ADA Curb Ramp New Construction Inspection Form (Perpendicular)

Nw 287 ave

24952.54

Nw Shaddon st

PERPENDICULAR RAMP (PR)

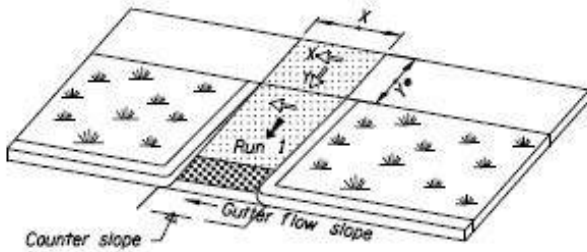
3.5 ≤ 2.0% ☐ >2.0% ☒

RR1 ICRR turn space position area of differential settlement
